SUBJECT: REMAINING ACTIONS ON THE ADVANCED BOILING WATER REACTOR (ABWR)
REVIEW

The purpose of this letter is to provide GE with additional staff comments on Amendment 34 to the ABWR standard safety analysis report (SSAR). Enclosure 1 contains a set of comments and SSAR pages with marked-up changes proposed by the staff. Enclosure 2 is a detailed discussion on two concerns resulting from the staff's review of Amendment 34. In order for the staff to complete the final safety evaluation report for the ABWR design, GE needs to provide an additional amendment to the ABWR SSAR that: (1) resolves the remaining items identified in my letter to GE dated May 3, 1994, and (2) addresses resolution of the primary containment pressure limit and the use of the containment spray as documented in Enclosure 2 of this letter.

STAFF FEEDBACK ON ADVANCED BOILING WATER REACTOR (ABWR)
STANDARD SAFETY ANALYSIS REPORT (SSAR) AMENDMENT 34

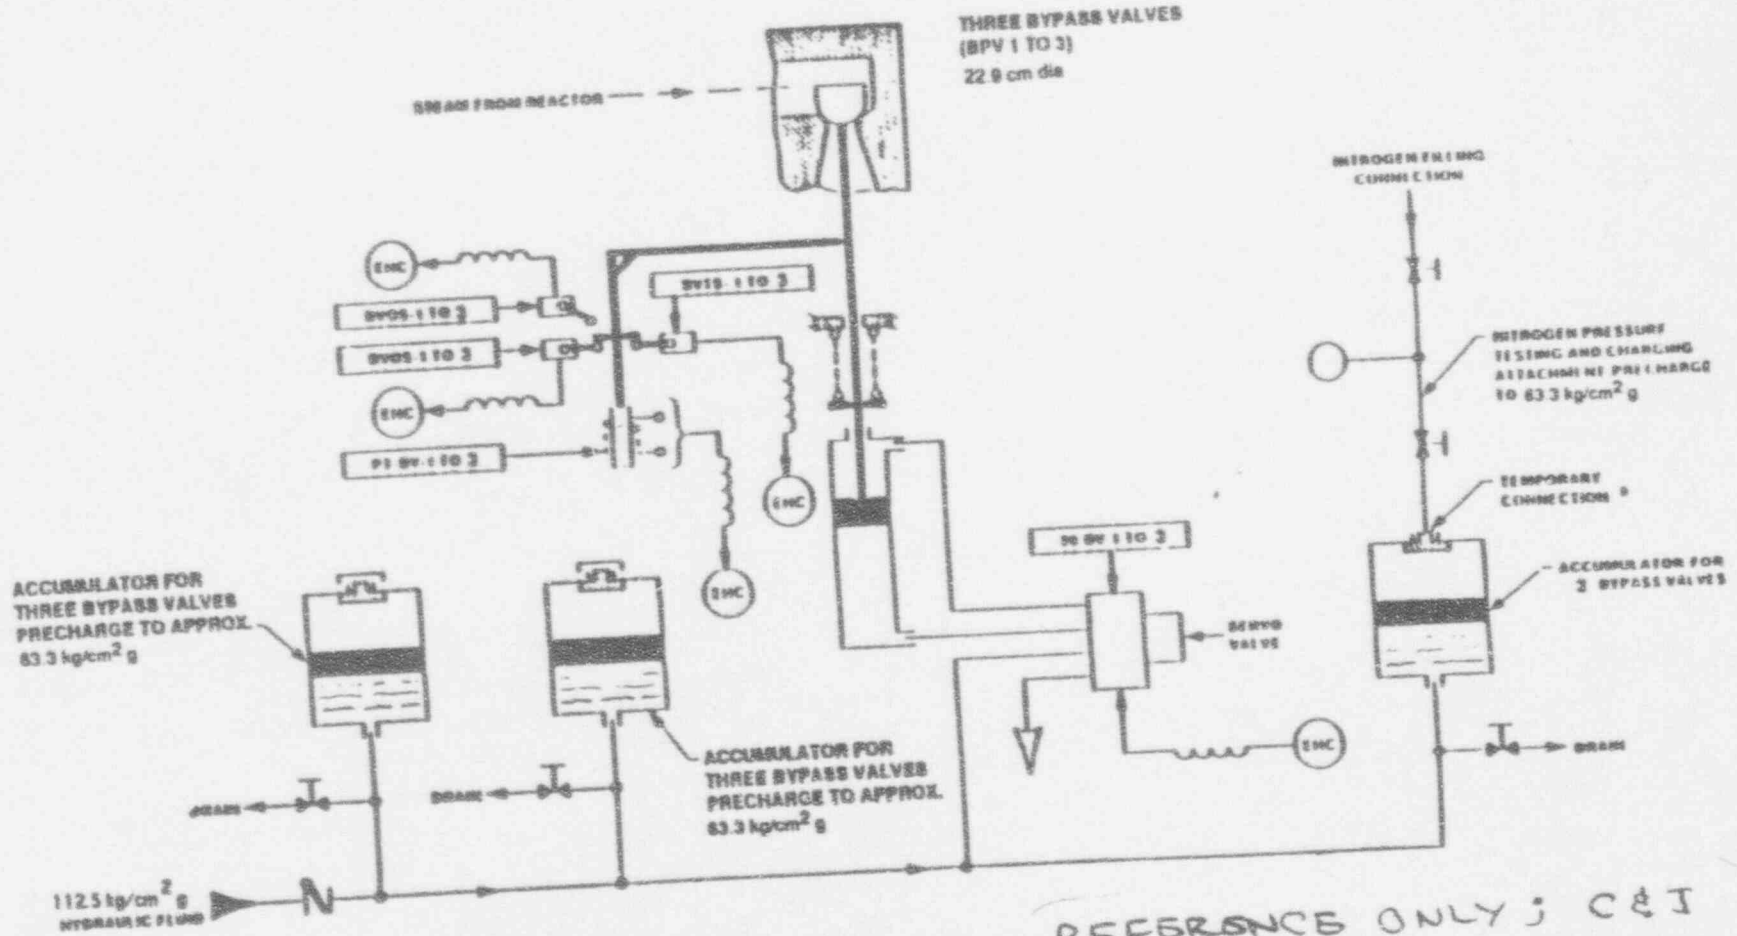
(c) The COL applicant will provide equipment and floor drain piping P&IDs ~~for~~ ^{as} part of the radioactive drain transfer system. See Subsection 9.3.12.4 for COL license information requirements. *Call of interconnection from the Radwaste Tunnel to the Radwaste Building Tankard*

X
when they
NOT added
in AM 34

Figure 10.4-9 Bypass Valve Control, Electro-Hydraulic Control Unit

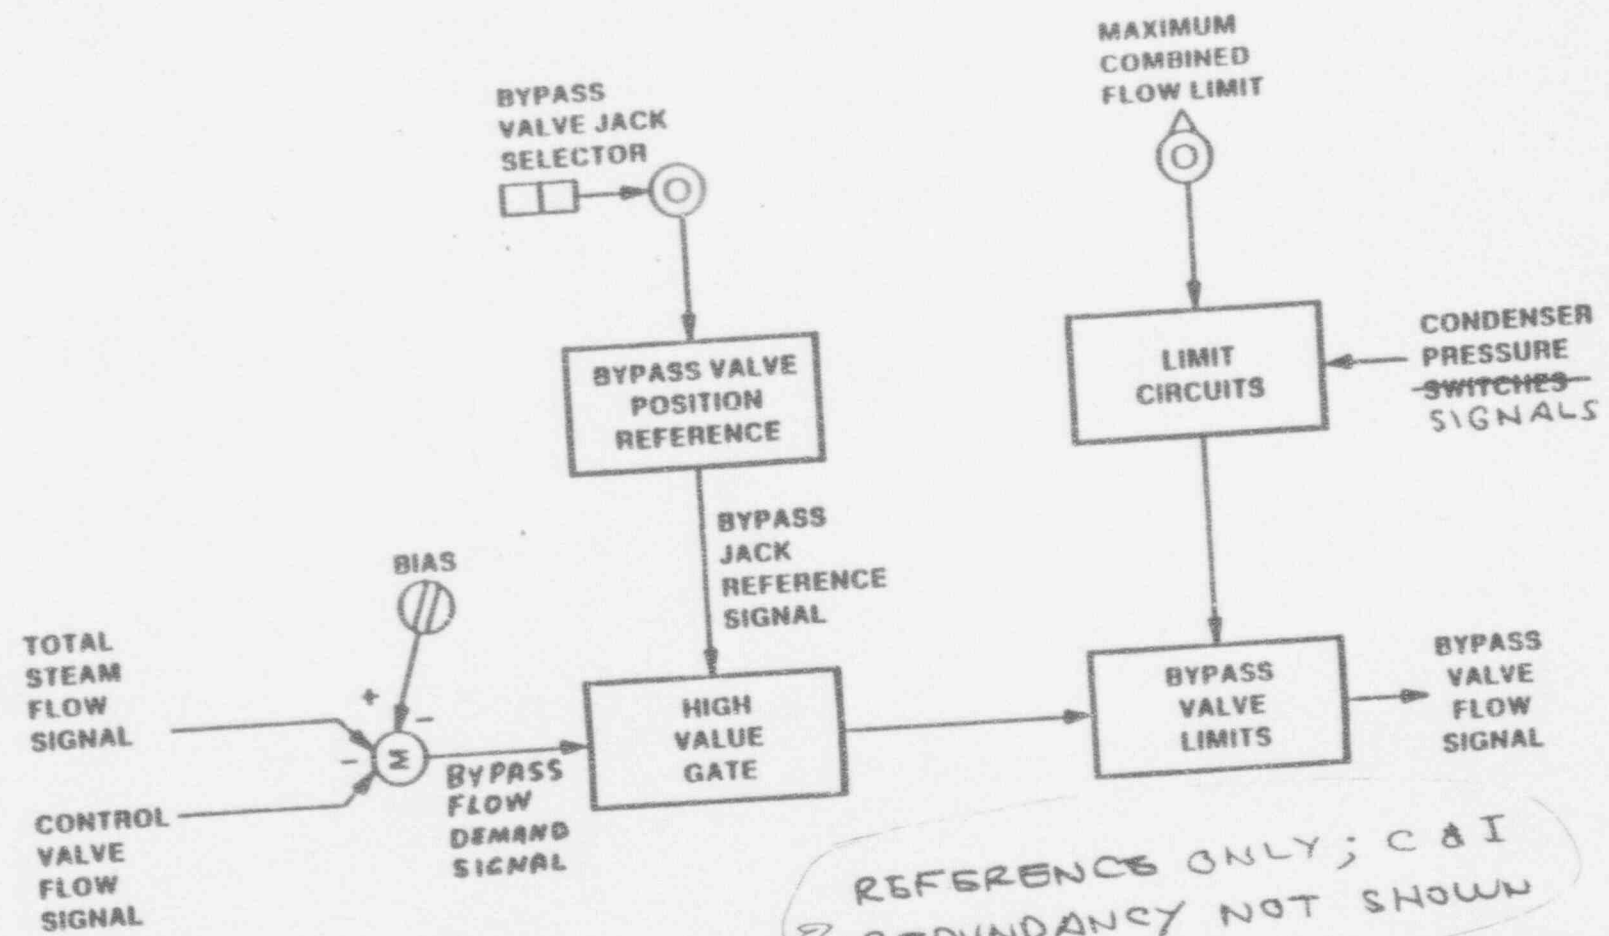
NOT in Am 34

Figure 15E-1 ATWS Mitigation Logic

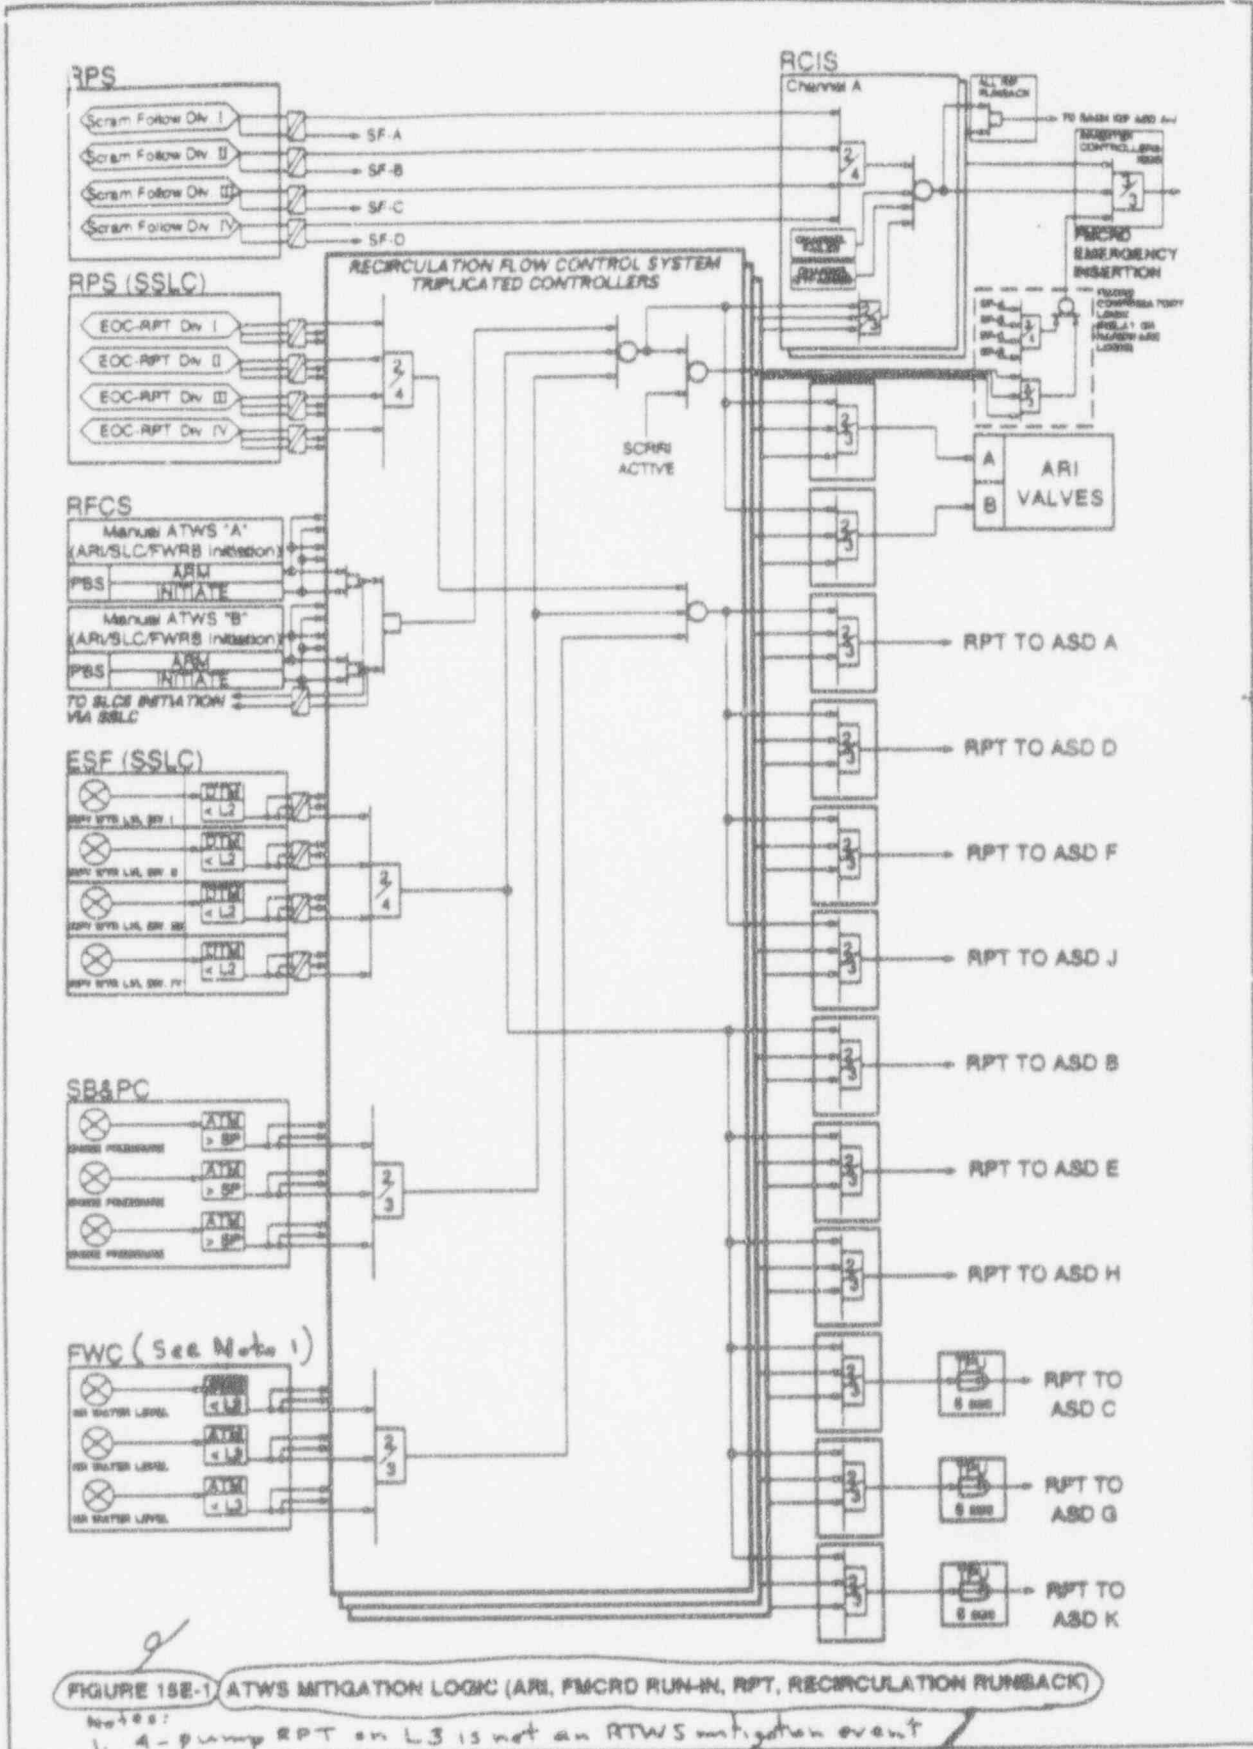
NOTE: NOT added to Figure in Rev 34

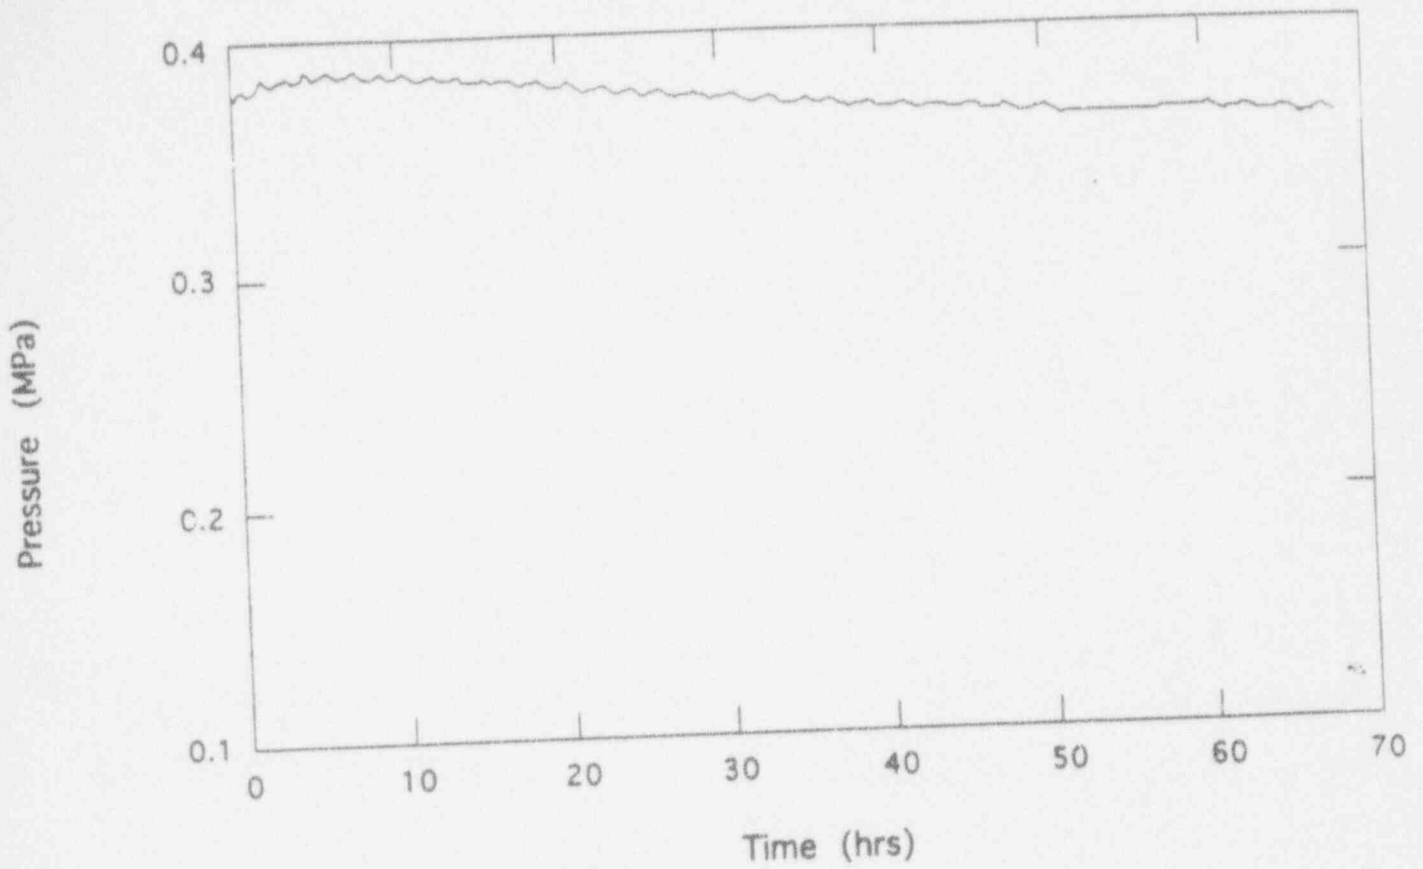
Where is this figure
19E.2-25?
